Rancho Del Rey Logistics Park Unit 3

City Plan Commission — July 3, 2025

CASE NUMBER/TYPE:	SUSU25-00049– Resubdivision Final
CASE MANAGER:	Saul Fontes, (915) 212-1606, FontesSA@elpasotexas.gov
PROPERTY OWNER:	Ben L. Ivey, LTD
REPRESENTATIVE:	Kimley-Horn
LOCATION:	East of Americas Avenue and North of North Loop Dr. (District 6)
PROPERTY AREA:	135.12 acres
VESTED RIGHTS STATUS:	Not Vested
PARK FEES:	\$135,120.00
ZONING DISTRICT(S):	C-4 c sc (Commercial/Condition/Special Contract)
RELATED APPLICATIONS:	SUSU24-00001 Rancho Del Rey Logistics Park

RESUBDIVISION FINAL APPLICATION

FINAL PLAT

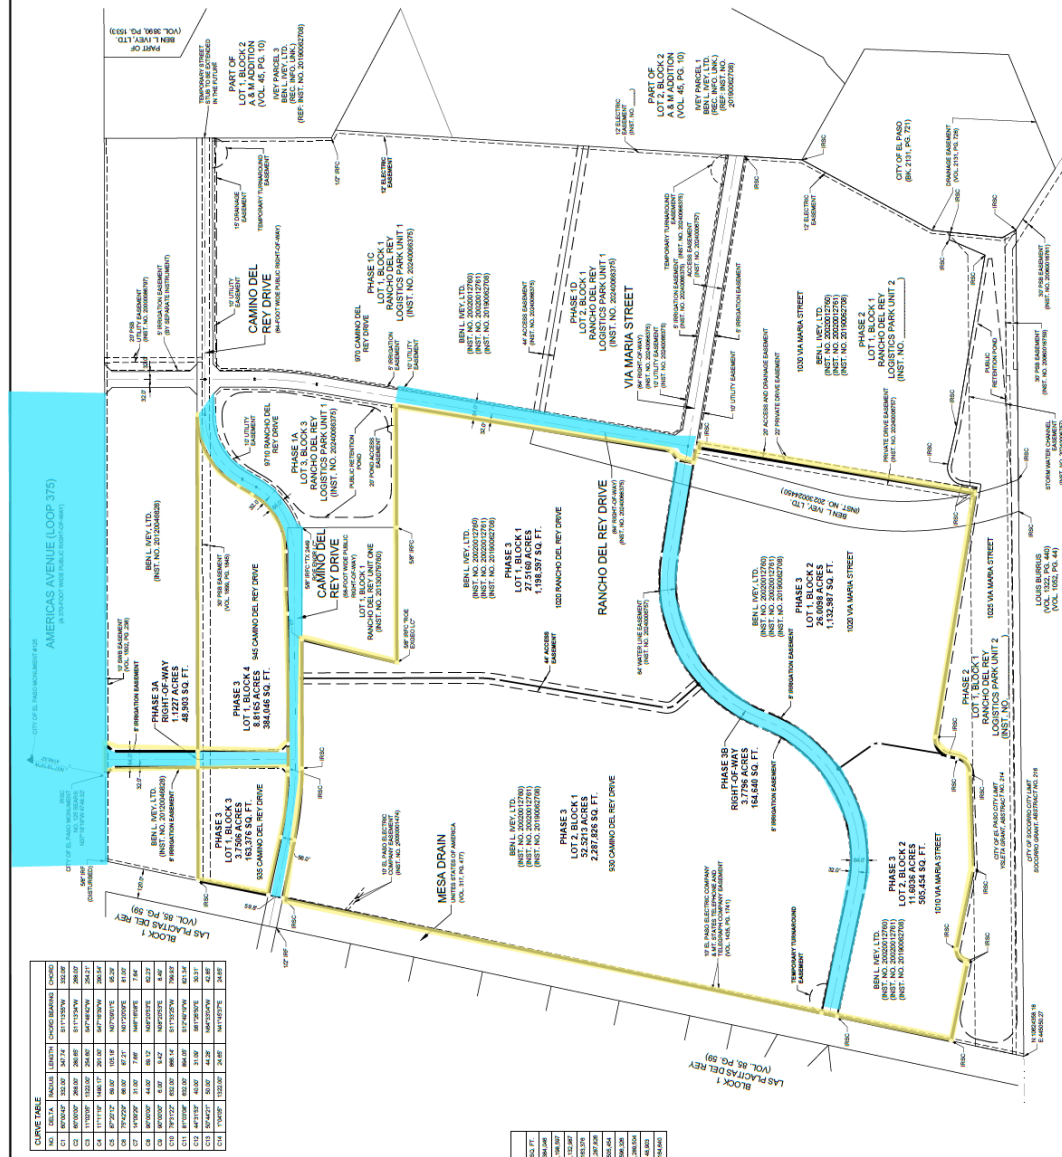
1. Submit to the Planning & Inspections Department – Planning Division the following prior to recording of the subdivision:
 - a. Current certificate tax certificate(s)
 - b. Current proof of ownership.
 - c. Release of access document, if applicable.
 - d. Set of restrictive covenants, if applicable.
2. Every subdivision shall provide for postal delivery service. The subdivider shall coordinate the installation and construction with the United States Postal Service in determining the type of delivery service for the proposed subdivision. In all cases, the type and location of delivery service shall be subject to the approval of the United States Postal Service.
3. Provide the half width of all R.O.W.s
4. Ensure all R.O.W.s are labeled with proper name.

1. Proposed Final Plat provided does Not have bearing and distances to verify mathematical closure.
2. There are two different exterior boundaries in the same plat unit, please verify or divided in two plats.

3. Show existing and proposed drainage flow patterns on the site plan and identify the discharge and/or storage location(s) for all stormwater runoff within the subdivision. Provide alternate drainage courses for historic flow, including flood zone contours in the preliminary plat (private ponds are not in the preliminary plat)

4. TXDOT review and approval are required of the proposed subdivision for drainage and access requirements. No storm-water is allowed into TxDOT R.O.W.

5. If lots are further subdivided, then additional private easement shall be required.
6. Provide and label R.O.W. Christo Del Rey Drive (missing west driveway?).

7. 6" rolled curb concrete is not allowed
8. The proposed bridge over the mesa drain shall be part of the improvement plans.

In reference to case SUSU25-00049 - Rancho Del Rey Logistics Park Unit 3, Texas Gas Service will need a 10' easement within or abutting the proposed 44' access easement, between lot 1 & 2, block 1, to provide gas service and two-way feed.
